A FLECK PERFORMANCE BULLETIN

May 28, 1999

2900 Lower Drive Cam Improvement

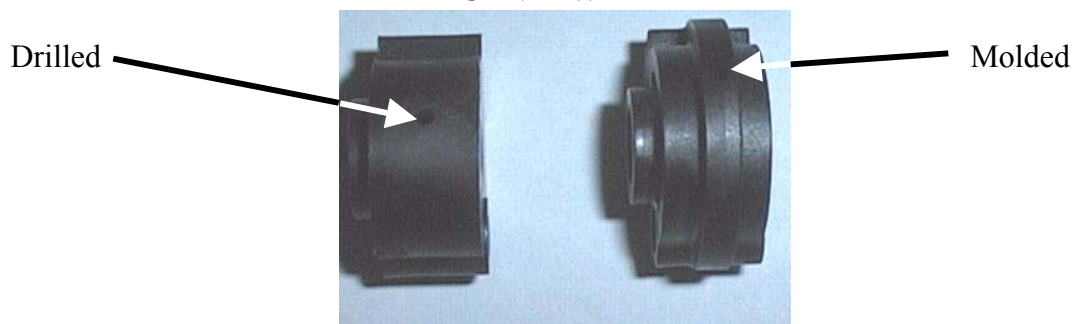
This new cam is stronger and has a molded hole for the connecting rod bearing. Having the molded hole, always in a fixed position, allows for a consistent alignment of the micro switches on the cam and increased product reliability. This change was implemented on May 1, 1999.
